### STAFF RECOMMENDATION 400 Broadway July 20, 2016

**Application:** New construction—addition; Alterations  
**District:** Broadway Historic Preservation Zoning Overlay  
**Council District:** 19  
**Map and Parcel Number:** 09306308200  
**Applicant:** Joshua Hughes, Tuck Hinton  
**Project Lead:** Melissa Baldock, melissa.baldock@nashville.gov

**Description of Project:** Application is to construct a rear and rooftop addition, to alter historic and non-historic windows, to alter window openings on the rear façade, and to alter the storefronts.

Figure 6. A mid-century historic photo shows the historic windows on 400 Broadway.

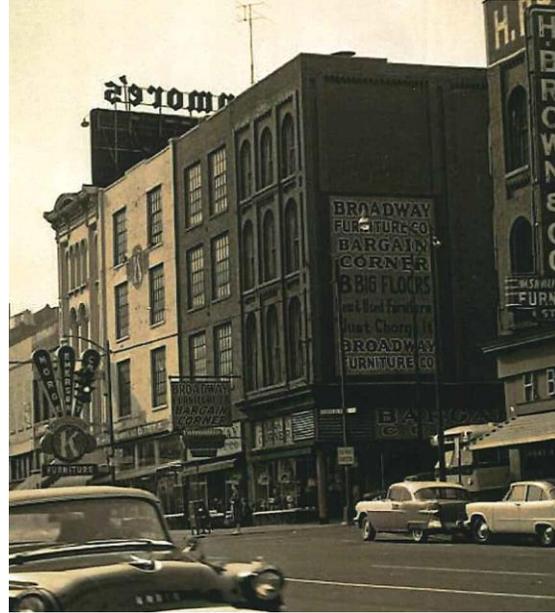
The applicant is proposing to replace the non-historic, double hung windows on the Fourth Avenue North façade and eastern/right portion of the Broadway façade. Although replacing the non-historic windows is appropriate, the proposed replacement window does not meet the design guidelines. The design guidelines state that “If replacement windows or window surrounds are necessary, replacements should replicate originals,” and the proposed replacement windows do not replicate the originals in design and operation. The current and the historic windows were double hung (Figure 6). The applicant is proposing to replace the double hung window with an awning window that is fixed at the top and pivots outward or inward. Staff does not find such a replacement window to be appropriate because the windows will result in a different look for the building. The operation of a window is intrinsically linked to its design and to the overall look of the building. A double hung window, with its overlapping and offset sashes, has a different look than a flatter window that is fixed at the top and swings either outwards or inwards. Windows are an important part of a historic building’s character, and installing windows that do not replicate typical historic windows of the period does not meet the design guidelines.

On the western/left portion of the Broadway façade, the applicant is proposing to retain the existing steel frames, and to re-glaze them. The applicant is also proposing the “frame[s] to be retrofitted for full operability.” Historically, the steel windows would have been fixed along the edges and would have had a central hopper window part that could swing in and out. Rather than restoring this historic operation, the applicant is proposing to retrofit the frame so that the entire window becomes an awning window. Again, the operation of a window is intrinsically linked to its design and to the overall look of the building. Retrofitting an historic window to operate as an awning window will likely require a change to the window frame or opening that would not be appropriate. Staff finds that these proposed changes to the historic windows do not meet the design guidelines.

Staff recommends that the Commission require that the new windows on Fourth Avenue North and the eastern/right portion of Broadway remain as double hung windows and not operate as an awning window. Staff also recommends that the historic steel windows remain fixed, and the central hopper element be restored if the applicant wishes the window to open in any way.

LEVEL 4 ROOF PLAN

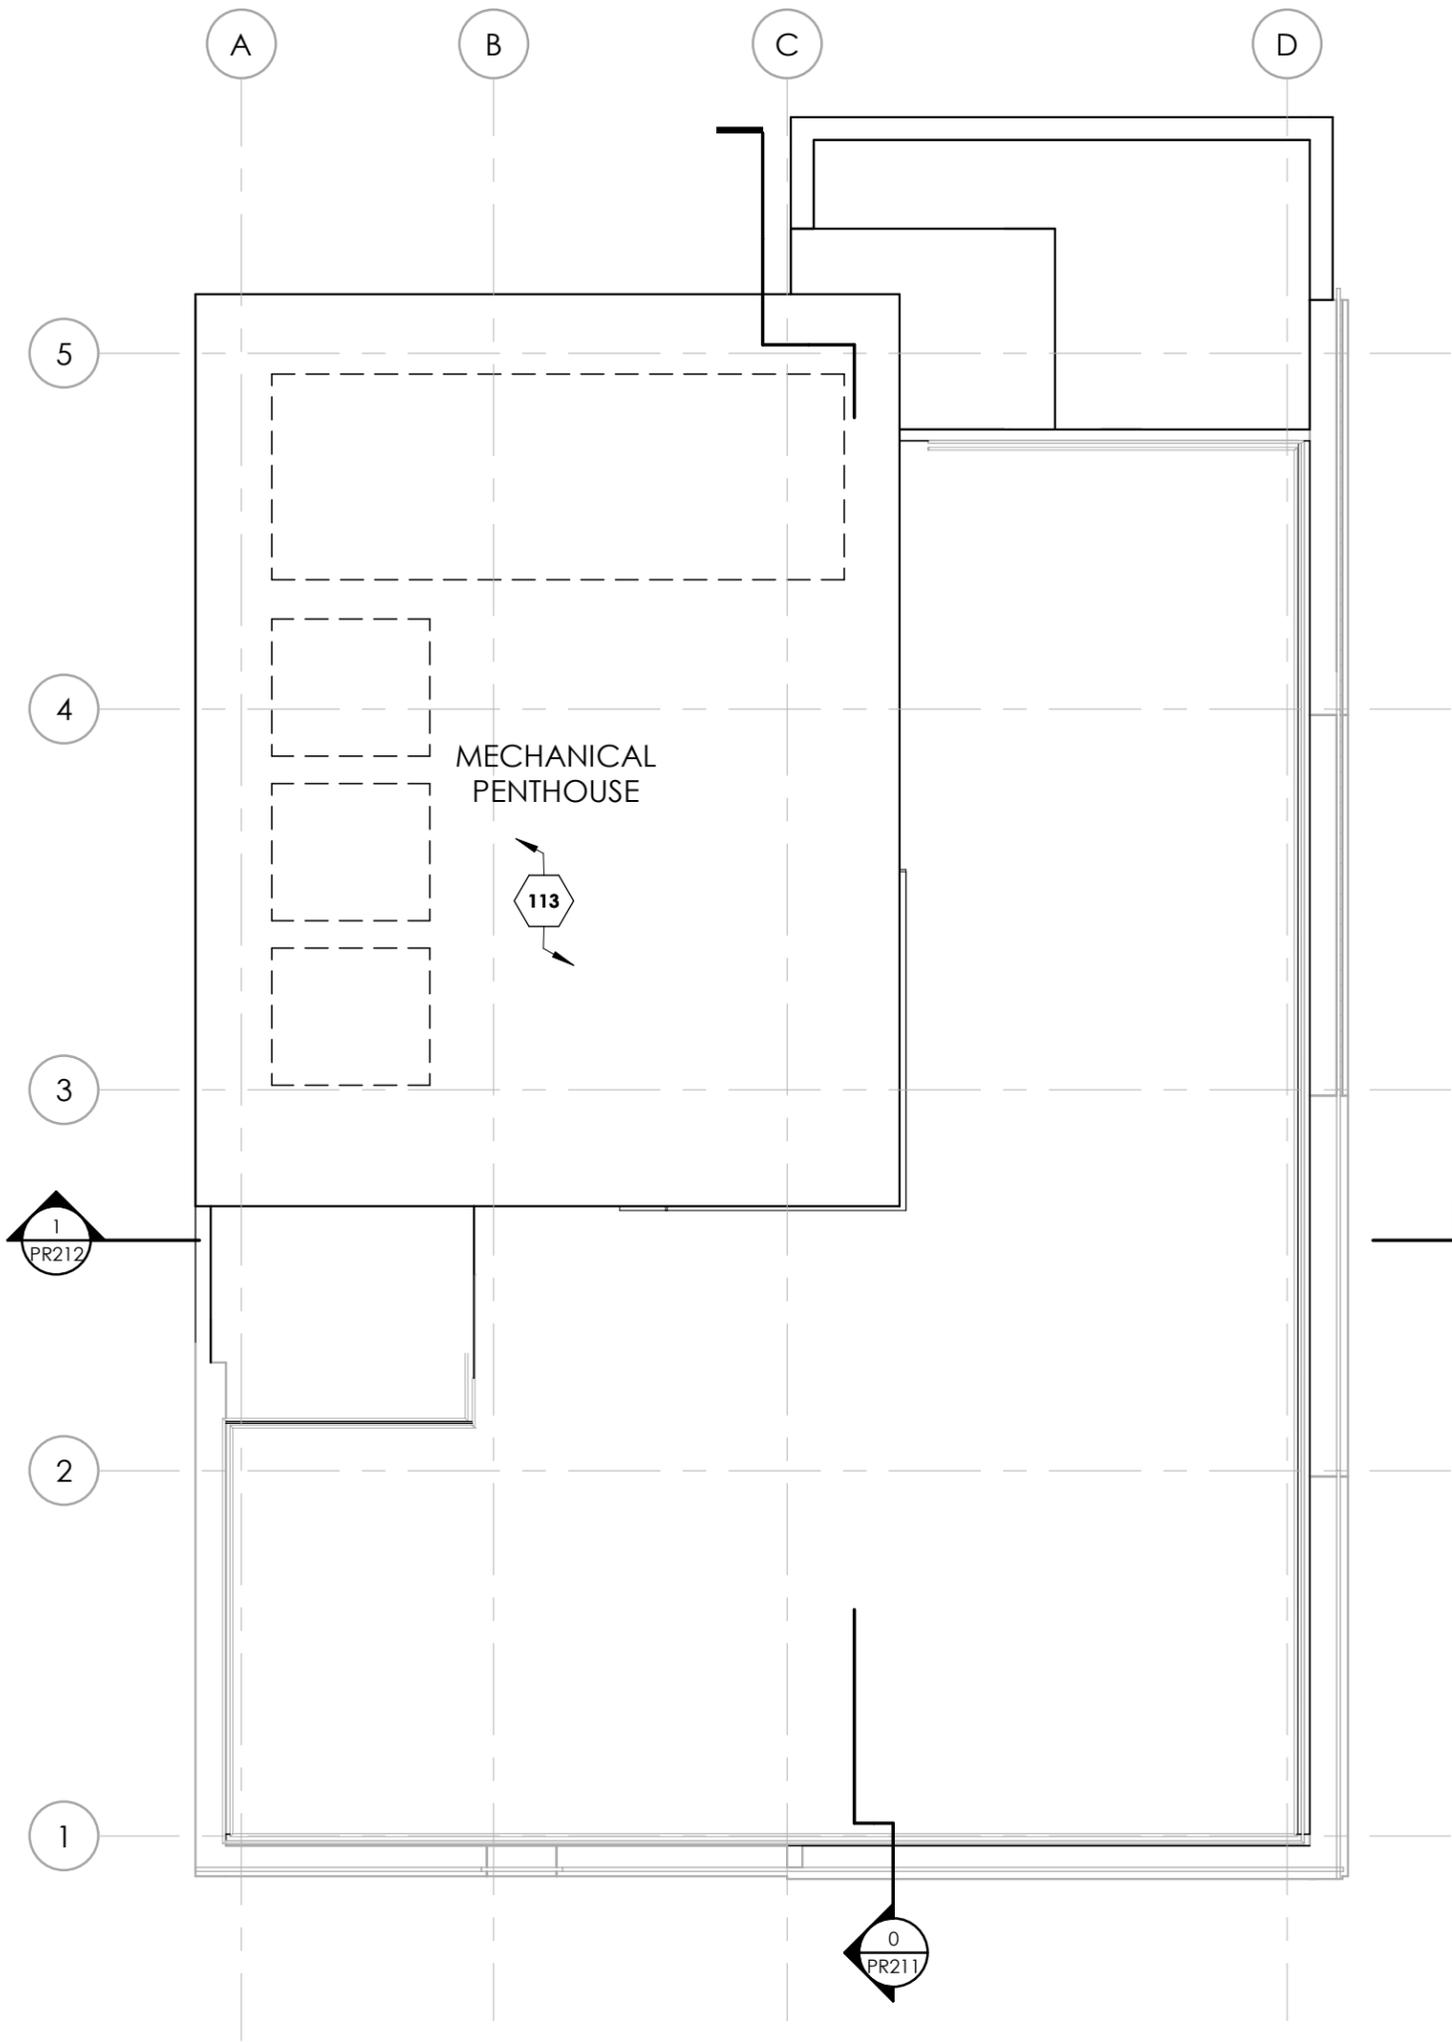
Rooftop Addition: The applicant is proposing a rooftop addition. The bulk of the addition is setback from the Broadway façade by the required thirty feet (30'). However a portion of the stair bulkhead encroaches on the thirty-foot (30') setback by approximately eight (8') feet. This stair bulkhead is no taller than five (5') and is slanted so that the tallest portion of the bulkhead is further back. The bulkhead will likely be at most minimally visible, and staff therefore finds that its encroachment to the required setback is appropriate. Similarly, the bulk of the addition is setback twenty feet (20') from the Fourth Avenue North façade, as is required. However, a stairwell bulkhead will extend approximately seven feet (7') into this setback. Staff finds this encroachment to be appropriate because the bulkhead has a maximum height of three feet (3') above the parapet and is designed so that its tallest portion is furthest from the parapet wall.

The design guidelines require that rooftop additions be a maximum of fifteen feet (15') above the parapet wall. The addition will extend thirteen feet (13') above the parapet wall along Broadway. Because the parapet wall steps down along the Fourth Avenue North façade, a back portion of the addition will extend sixteen feet (16') above the parapet at its lowest point (Figure 8). Staff finds this to be appropriate because the majority of the addition will be less than fifteen feet (15') above the parapet, and because the portion of the addition that extends taller because of the lower parapet is pushed the rear, where it will be less visible.

BROADWAY ELEVATION

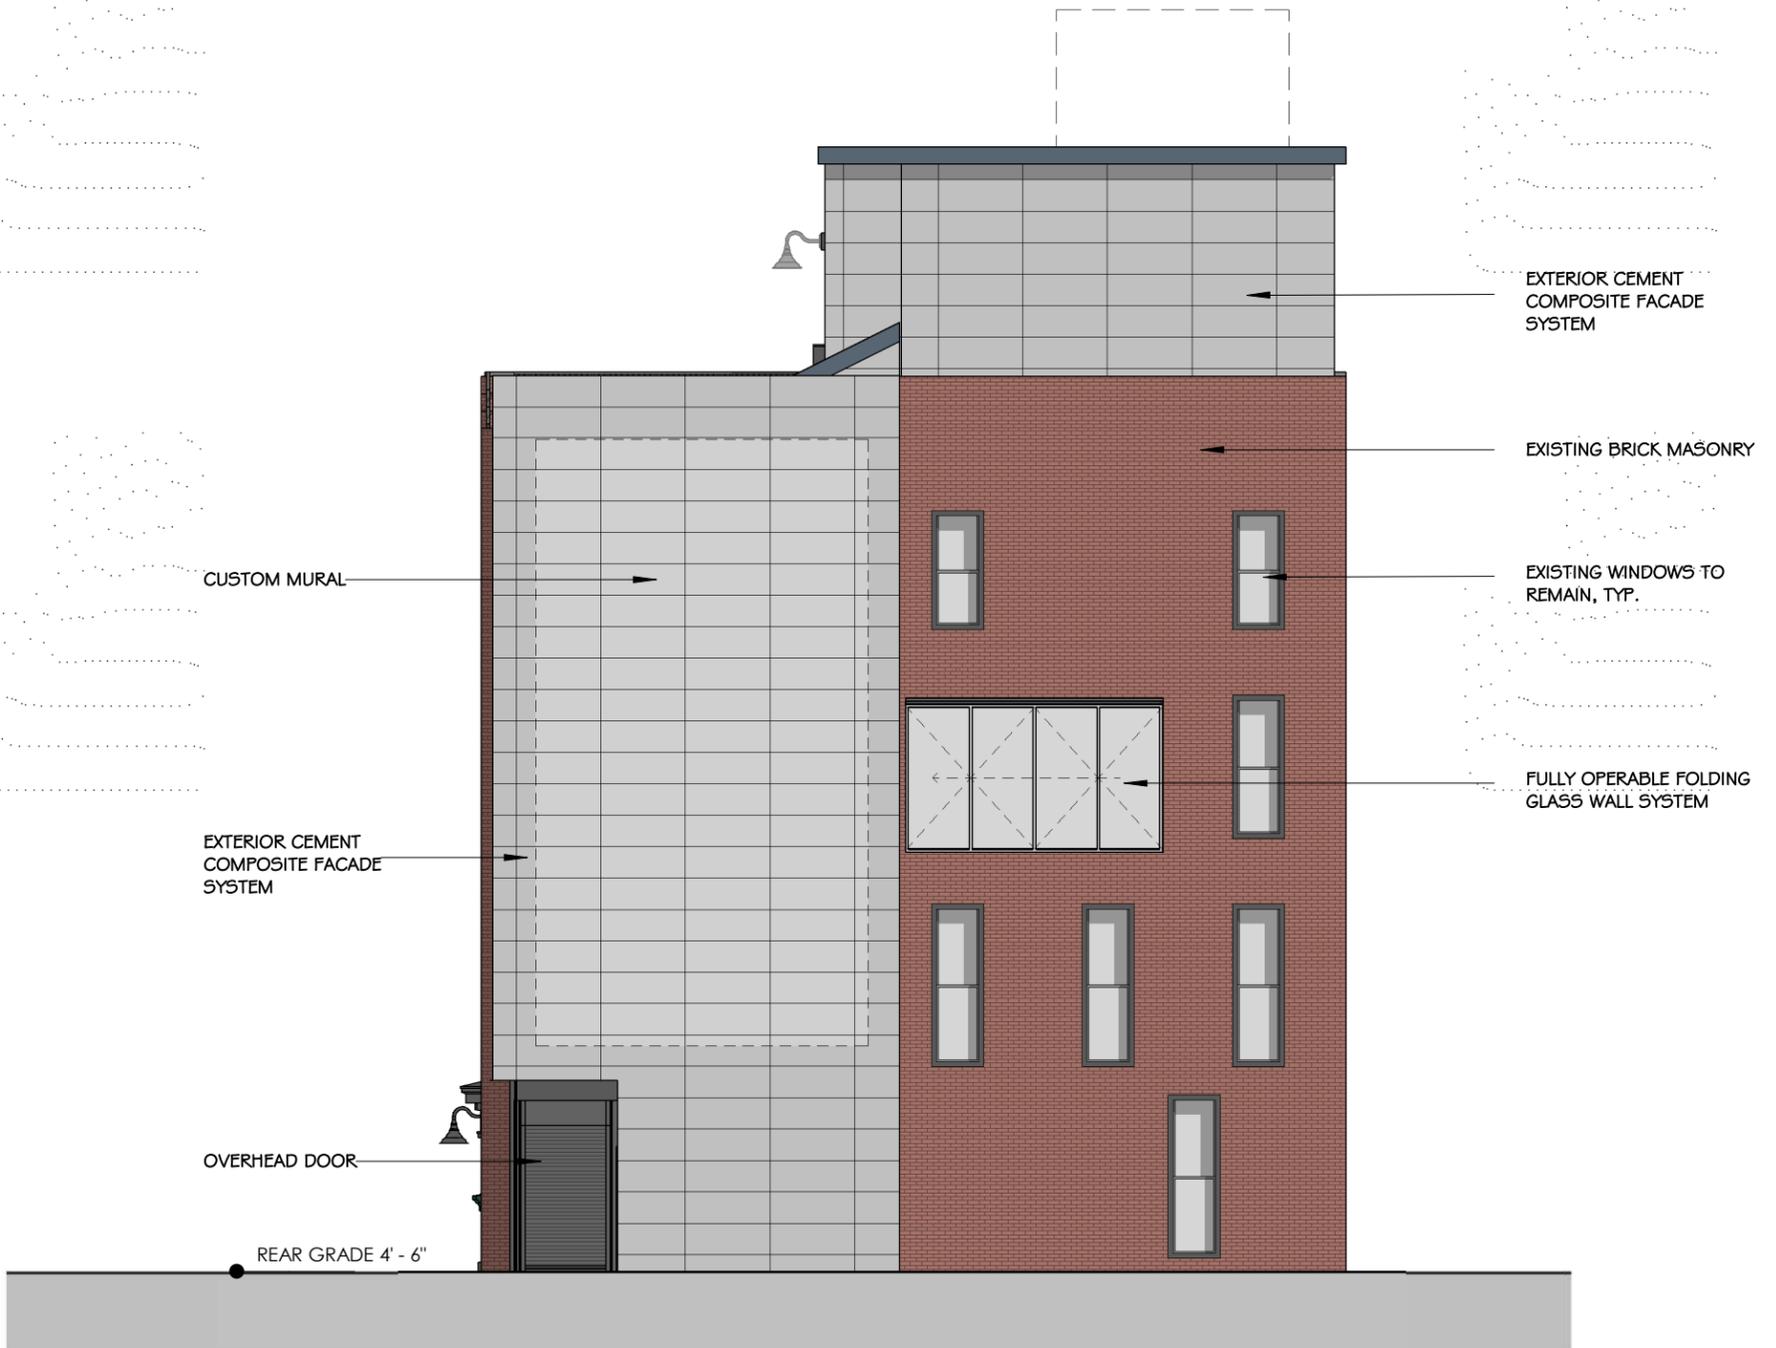
Illumination: The applicant is proposing to install goose neck lamps on the storefront to down light the storefront area. In total, ten (10) goose neck lamps are proposed for the Broadway façade, one (1) is proposed for the corner, and seven (7) more are proposed for

the Fourth Avenue North façade. There are a total of 18 goose neck lamps proposed. The design guidelines state, “If lighting is installed, it should be concealed or simple and unobtrusive in design, materials, and relationship to other façade or elevation elements.” Although the Commission has approved goose neck lighting for signage in the past, staff finds that the number of light fixtures does not meet the design guidelines because it is not “simple” or unobtrusive. Staff recommends that one goose neck lamp be installed per storefront bay, which will reduce the total number of lamps to eight (8).

The applicant is also proposing low profile accent up-lighting installed at the top of the cornice. Staff recommends that the applicant provide more information as to the number of up-lighting elements and their location to ensure that they meet the design guidelines.

The addition's materials include an aluminum storefront system with a fully operational glass wall system. Portions of the addition will be clad in an exterior cement composite façade system, and staff recommends approval of a sample material prior to purchase and installation. Goose neck lights will also be installed along the glass portions of the addition. Staff finds the number of lights to be excessive and recommends two lights on the Broadway elevation and three on the Fourth Avenue elevation.

1. The number of gooseneck lamps on the ground floor be reduced to have just one lamp per storefront bay and that the lamps on the rooftop addition be reduced to two on the Broadway façade and three on the Fourth Avenue side;

2. The applicant provide more information as to the number of up-lighting elements and their location to ensure that they meet the design guidelines;
3. The replacement windows for the Fourth Avenue North façade and the eastern/right portion of the Broadway façade be double hung windows with a traditional framing system and offset overlapping sashes, and staff review the final window selection prior to purchase and installation;

4TH AVE SECTION

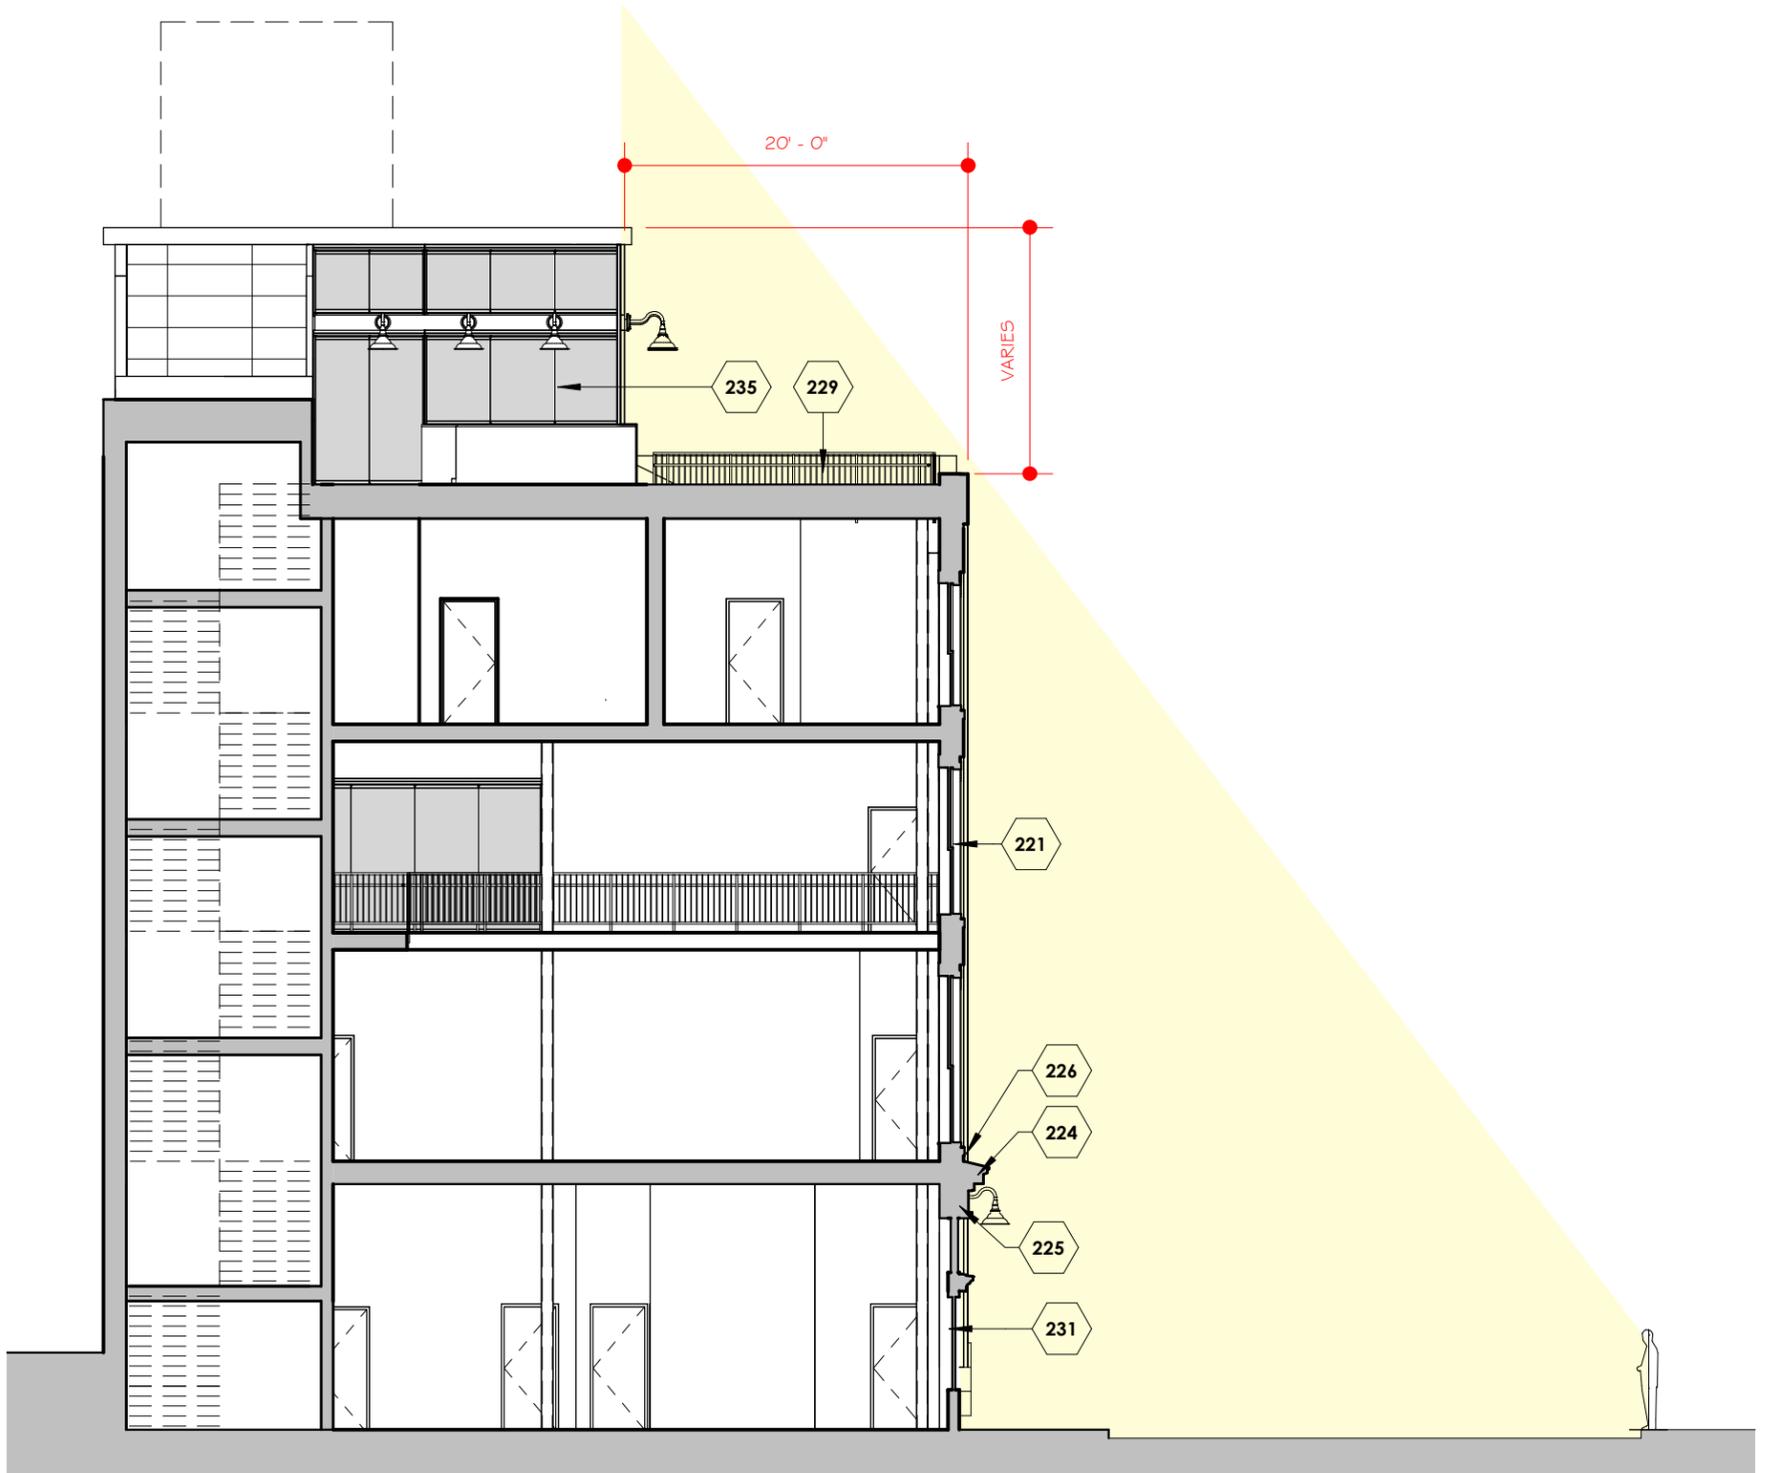
The applicant is also proposing to install a railing on the roof. Along the Broadway façade, the railing will not extend above the line of the parapet, and therefore it does not need to be recessed eight feet (8'), as is typically required. Along Fourth Avenue North, because the parapet drops in height, between one and three feet (1' – 3') of railing extends above the parapet wall. In the past, the Commission has required that the railing sit back eight feet; however, since much of it is covered by the parapet wall, Staff recommends the Fourth Avenue railing be recessed four feet (4'). This will lessen its visibility and assure that the addition sits back from the side wall, as required.

6. The railing be recessed four feet (4') from the Fourth Avenue façade.
